**A Suggested Consideration to the Draft Regulation on
Prospecting and Exploration for Cobalt-rich
Ferromanganese Crusts**

(The size,Block and number for Exloration)

Guangzhou Marine Geological Survey

Fig.1 The photo picture by TV camera showed the Crusts covered by the sediments(whiteness). The location on the seamounts of A-H identified in Fig.3 where the water depth and slope is variational.

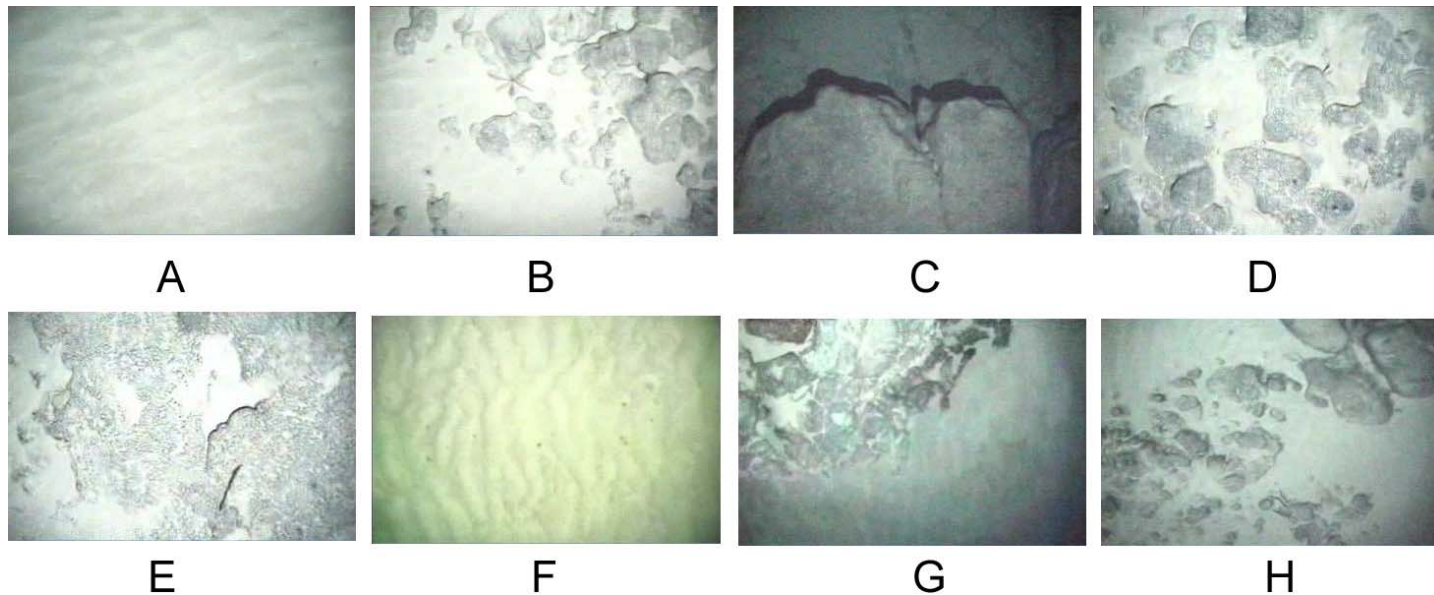
In fact, not all blocks are full covered by the crusts. Some areas of the blocks are covered by sediments or base rocks(fig. 1). whatever the exploration or the nominate blocks for the contractor.

Fig. 2 The relationship of water depth vs slope of a typical guyot by multibeam bathymetry.

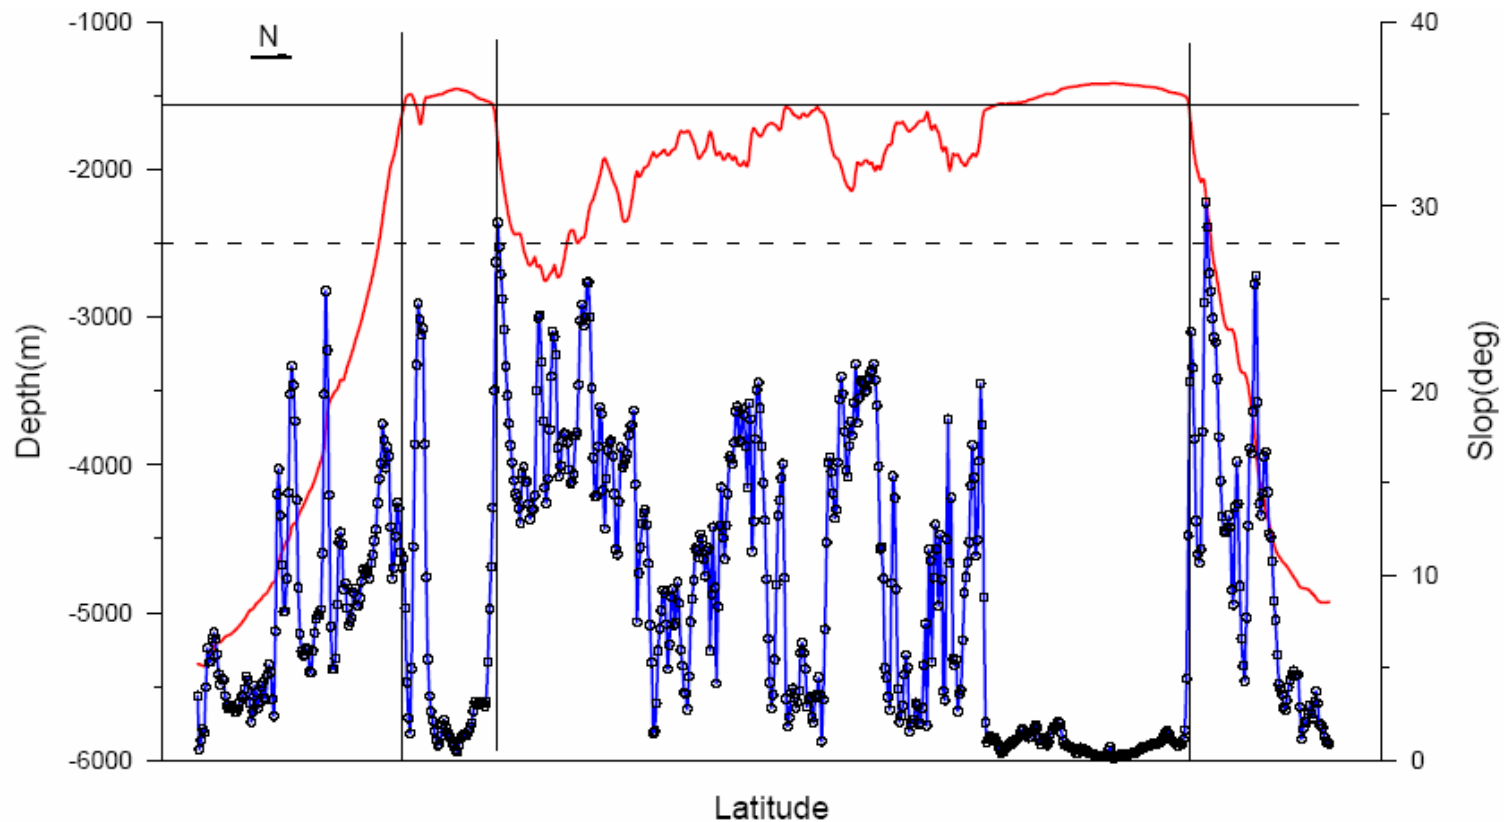
6. According to the subbottom profiler, seismic, grab sampling, coring sampling, TV grab investigation on the north-equatorial Pacific seamounts by COMRA, most flat surface area of the guyots are covered by sediment with tens of meters thickness. (fig.2) where there is no distribution of crusts. At the edge of the guyots, there are the area with rough slope ten to twenty degree in topography(fig.3) where mining is impossible with present mining technology. According to our statistics, 75 percent of the flat-top of the seamounts are covered by sediments, which should be cut-off for exploration.
